Technical Bulletin / Safety Alert

Unique ID No: DES2012-TBSA-04 **Rev:** 1

Subject: MDR090376DES Exhaust System - Incident Notification

Applicable to: VLI Diesel Pty Ltd Diesel Engine Systems covered under design registration no. MDR 090376 DES (Drifrunner & Brumby)

Figure 1: MDR090376DES Exhaust Conditioner Assembly

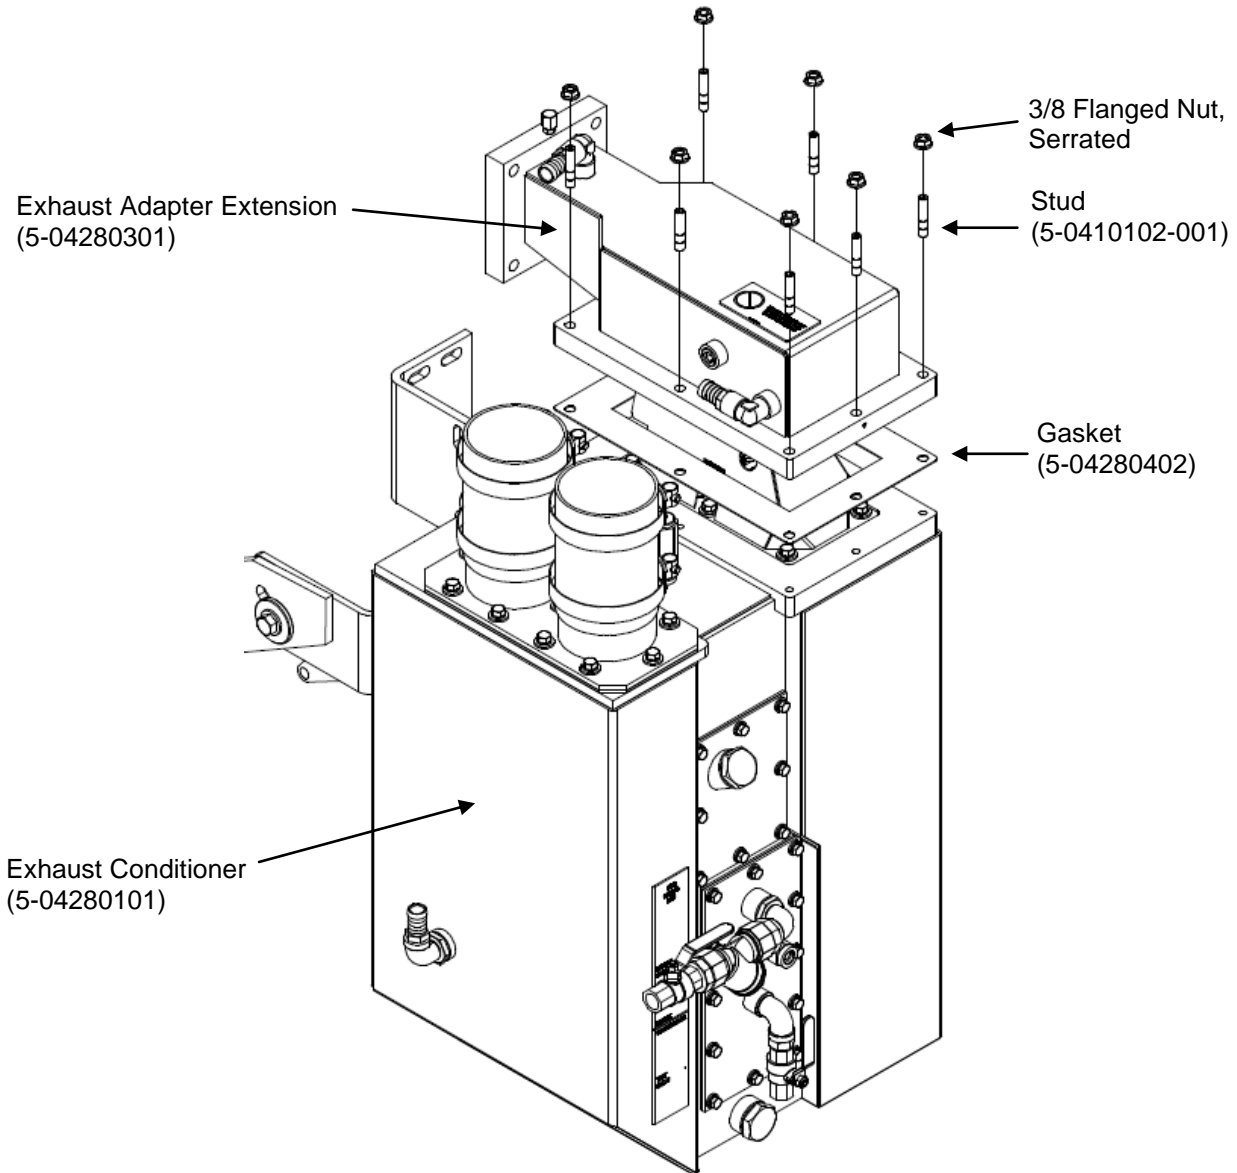
Investigation of the incident by VLI identified that machining to the mounting flange on the exhaust conditioner tank had reduced the depth of one of the threaded bolt holes to the minimum nominated tolerance; subsequently the bolt appeared to have become thread bound at this location, resulting in the reported leaking joint. It was considered likely that the joint integrity was intact on initial installation, and that subsequent in-service thermal cycling had resulted in the failure of the joint integrity.

Upon review of the exhaust conditioner tank to exhaust adapter extension assembly design and the allowable minimum tolerances of the component flanges, it was identified that there was potential for the thread engagement of the nominated bolts to render them thread bound.

The revised fastener installation for the exhaust adapter extension to exhaust conditioner fixed joint is shown below:

To address the potential for the issue that resulted in the incident described above, VLI has developed a stud fastener (Part No. 5-0410102-001) to replace the previously used hex head bolts in this position.

All new Design Registered Diesel Engine Systems, MDR090376DES, to include the stud fastener (Part No. 5-0410102-001).

VLI recommends that end users and equipment owners of Design Registered Diesel Engine Systems, MDR090376DES, install the stud fastener (Part No. 5-0410102-001) at the next scheduled Code D mechanical inspection.
